Reply to: 2430 Commercial Timber Sales

Subject: Hunter's Lake Timber Sale, proposed

Subject: Comments on Ross Frid's Hunter Lake Sale  
(Reference 7/29/82 memo)

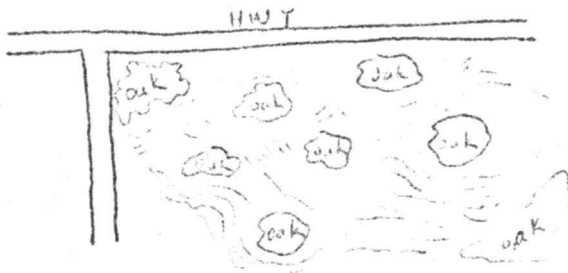
Unit #3 - I had the most concern with this unit. I realize it's main purpose is to create habitat for the D-W, but I still recommend the following. I hope these changes will be acceptable for wildlife.

a) where oak exists - mostly in the north section and along the south edge, I'd like to see you have a J.P. only removed. This will, of course effect the habitat. Perhaps a large enough block can be left in the center of the unit (J.P. clear-cut).

b) The center portion should be left as originally proposed (clearcut), but I'd like to see it treated for slash. If burning is a must, try to not burn the oak portions. I suggested to Lee that perhaps the oak portions could be roller chopped. This would only be in areas where oak is not too thick. Perhaps a scheme as shown below would work.
